September 19, 2011  
U7-C-NINA-NRC-110118

South Texas Project  
Units 3 and 4  
Docket Nos. 52-012 and 52-013  
Supplemental Response to Request for Additional Information

RAI 09.02.05-1, Supplement 1

COLA Part 2, Tier 2, Figure 1.2-35 Section 1, will be revised as follows:

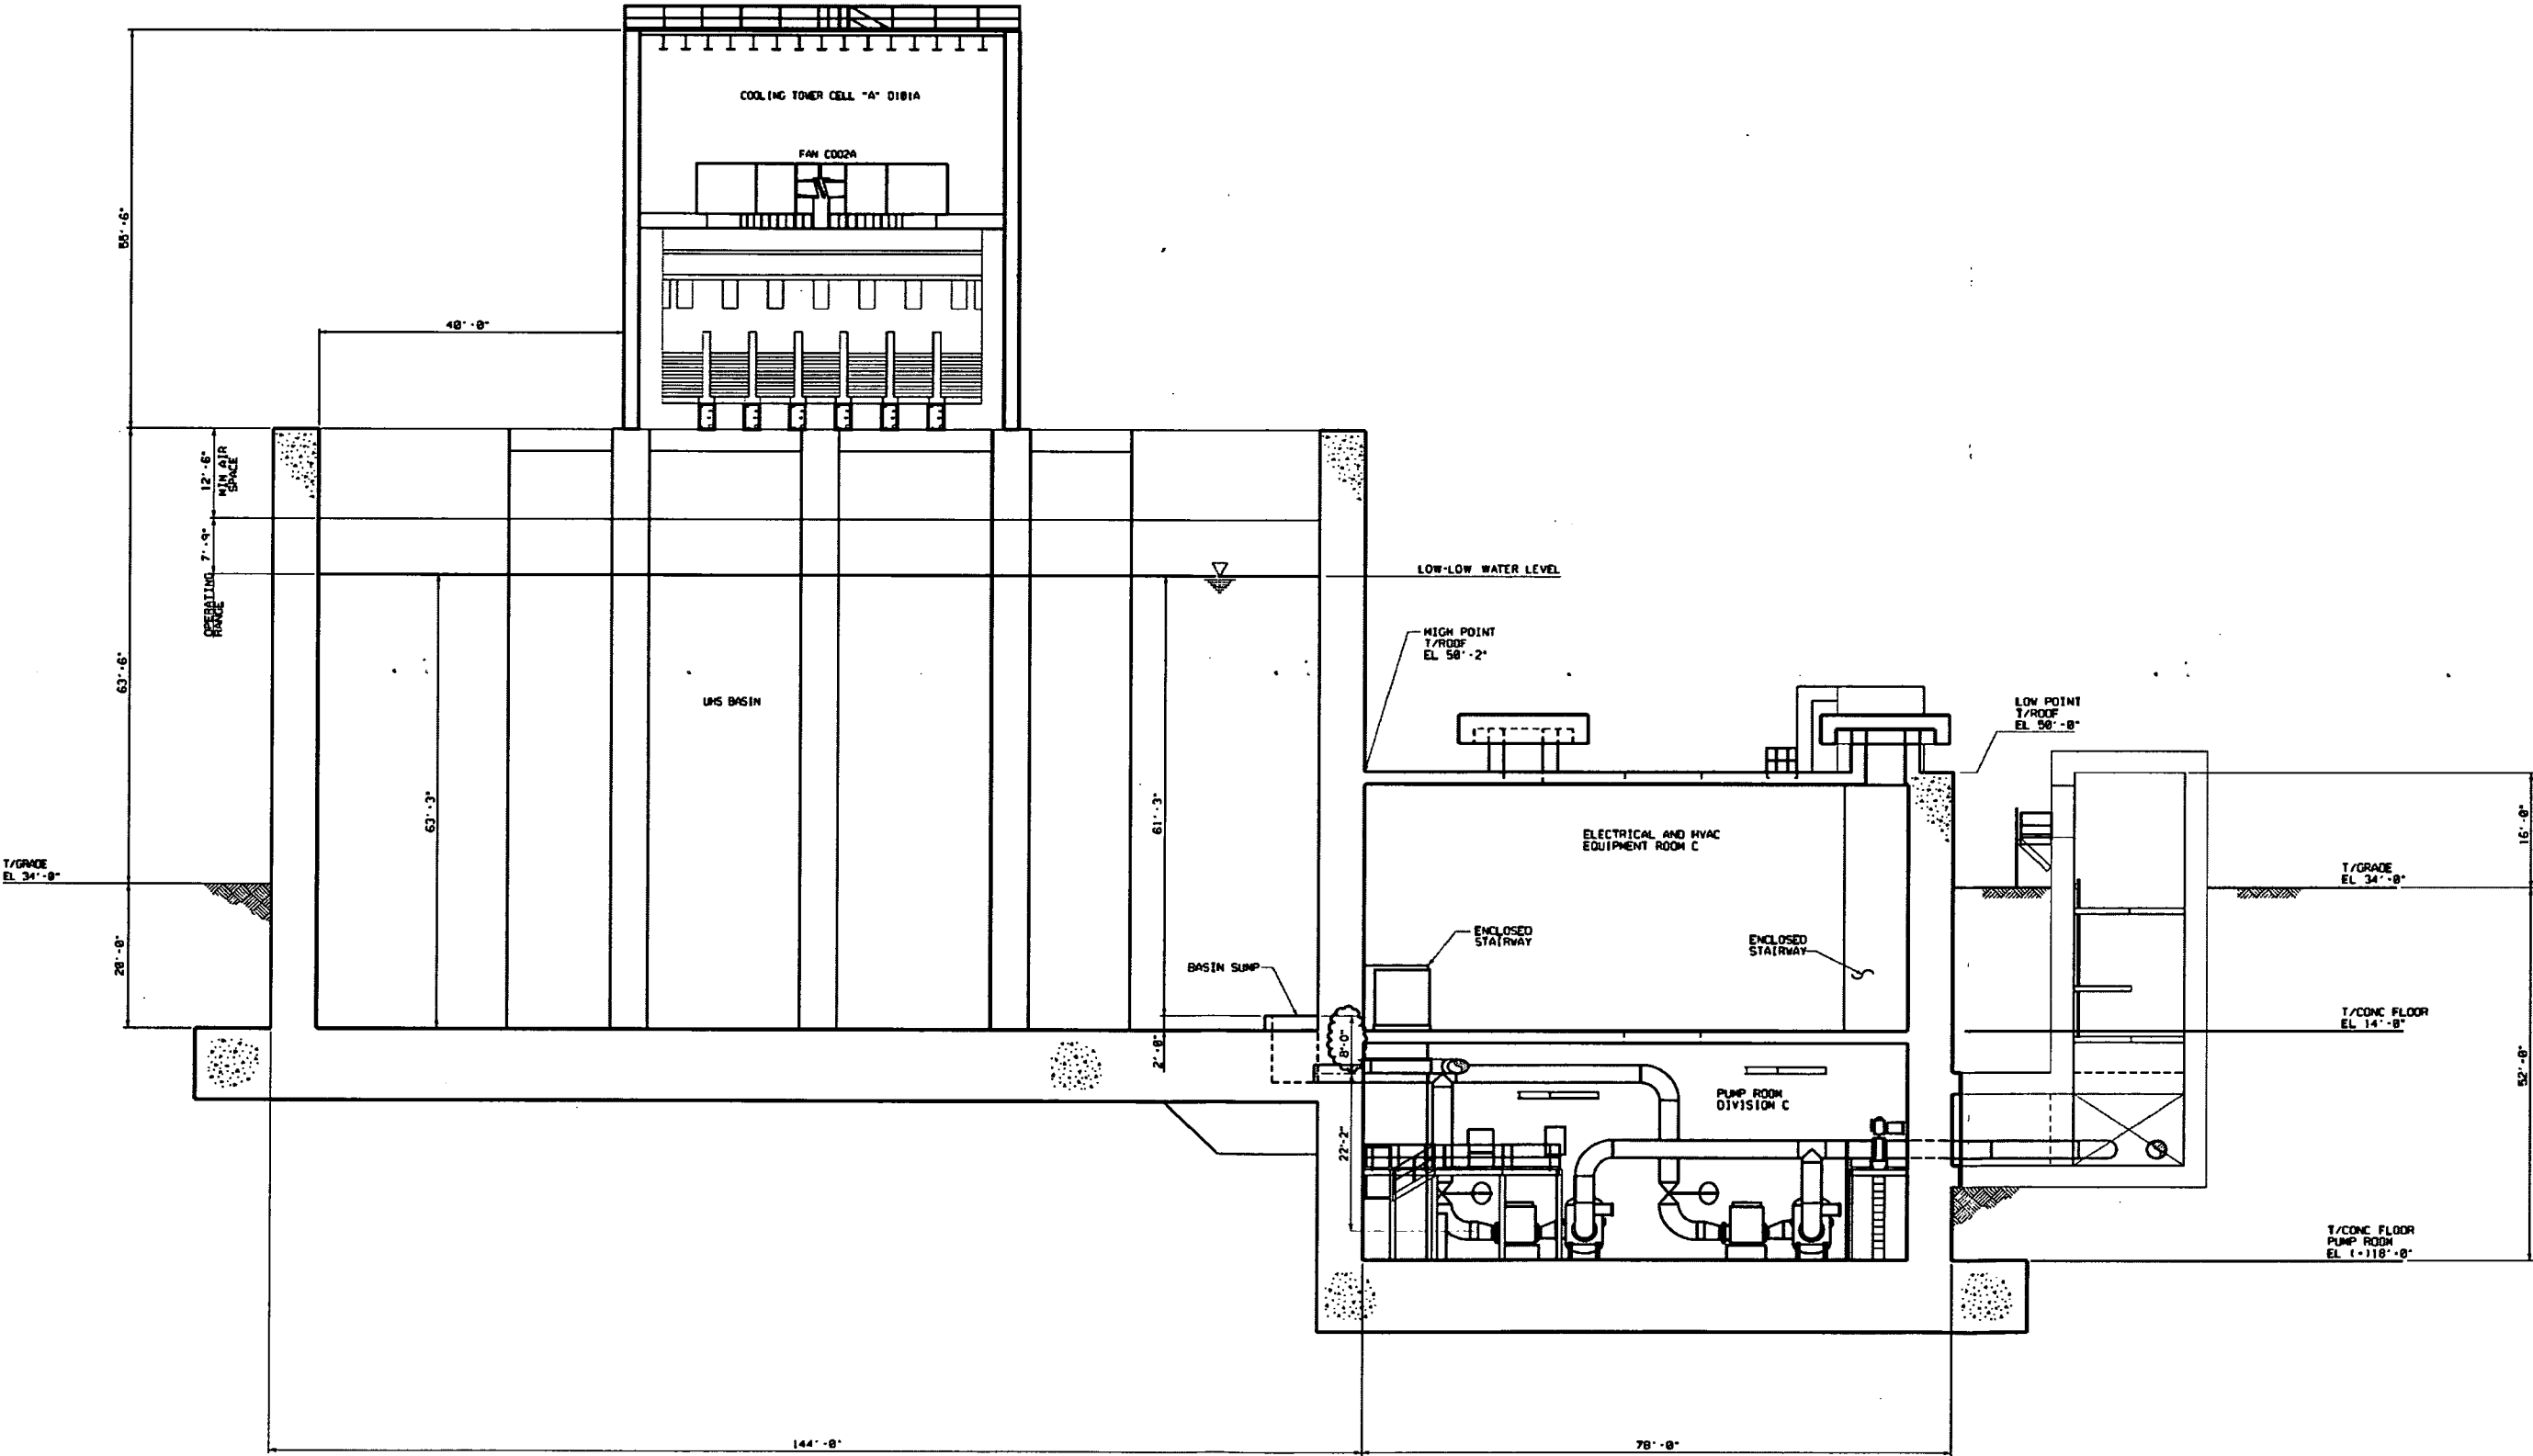
The original response to this RAI, submitted with STPNOC letter U7-C-STP-NRC-090123, dated August 28<sup>th</sup>, 2009, provided clarification on the elevations of several points of interest related to the Ultimate Heat Sink (UHS). This supplemental response with COLA markups provides consistency with subsequent RAI responses, and corrects minor discrepancies in the COLA. Information and COLA revisions provided in the original response are not affected by this supplemental response with the exception of the revision to Tier 2 Figure 1.2-35.

As indicated in COLA Part 2, Tier 2, Subsection 9.2.5.5.2(5), the bottom of the UHS is provided with a 0.3 meter-tall curb to prevent the migration of sediment into the RSW system. This curb was also described in the response provided to RAI 09.02.05-8, included in STPNOC letter U7-C-STP-NRC-100045, dated February 18<sup>th</sup>, 2010. The revised Figure 1.2-35 provided with the original response to RAI 09.02.05-1 was affected by the subsequent response to RAI 03.07.01-13, Supplement 2, submitted with STPNOC letter U7-C-STP-NRC-090230, dated December 30, 2009, which showed the curb height in Figure 1.2-35 as 0.6 meters (2 feet). The curb height of 0.6 meters is greater than the 0.3 meters height originally set for protection against sediment migration. This requirement is clarified in the COLA mark-up to Subsection 9.2.5.5.2(5), provided in the Enclosure. A revision to Figure 1.2-35 which corrects a minor discrepancy as indicated by a cloud which reflects a change from COLA Revision 6 is also provided in the Enclosure.
